Access Compliance Report

Public Rights-of-Way

(Curb Ramps)

Intersection ID: 44077	Main Street: NEWLANDS_CORNER_LN	Cross Street: FOREST_RUN_LN	Location: NE
ADA ID: 785A7CE2BB23	Ramp Type: PerpDiag	Initial Pass/Fail: Fail	Overall Compliance: No
Severity Score: 35			
Codes/Mitigation Info/Possible Solution		Field Measurements/Component Compliance

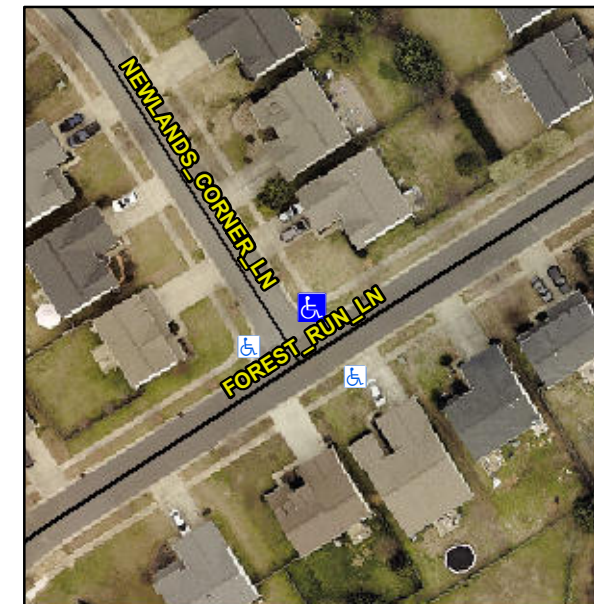
Compliance	Description	Data	Compliance	Description	Data
N/A	Ramp Length (in)	73.0	Yes	Ramp Slope (%)	5.0
No	Ramp Width (in)	25.0	Yes	Ramp XSlope (%)	2.0
N/A	Flare Type LT	N/A	N/A	Flare Type RT	N/A
N/A	Flare Slope LT (%)	N/A	N/A	Flare Slope RT (%)	N/A
N/A	Flare Traversable LT?	N/A	N/A	Flare Traversable RT?	N/A
N/A	Landing Length (in)	N/A	N/A	DWS Provided?	N/A
N/A	Landing Width (in)	N/A	N/A	DWS Contrast?	N/A
N/A	Landing Slope (%)	N/A	N/A	DWS Length (in)	N/A
N/A	Landing X Slope (%)	N/A	N/A	DWS Full Width?	N/A
N/A	Landing Curb? (Y/N)	N/A	N/A	DWS Offset (in)	N/A
N/A	Shared Landing?	N/A			
N/A	Gutter Ponding?	N/A	N/A	Gutter Slope (%)	N/A
N/A	Gutter Lip Ht (in)	N/A	N/A	Gutter X Slope (%)	N/A
N/A	Painted X Walk1?	No	N/A	Painted X Walk2?	No
	X Walk 1 Direction	To SW		X Walk 2 Direction	To SE
N/A	X Walk 1 Width (in)	N/A	N/A	X Walk 2 Width (in)	N/A
	X Walk 1 Slope (%)	4.6		X Walk 2 Slope (%)	2.1
	X Walk 1 X Slope (%)	2.6		X Walk 2 X Slope (%)	2.3

Remove & Replace Curb Ramp With Two New Directional Ramps or Equivalent.
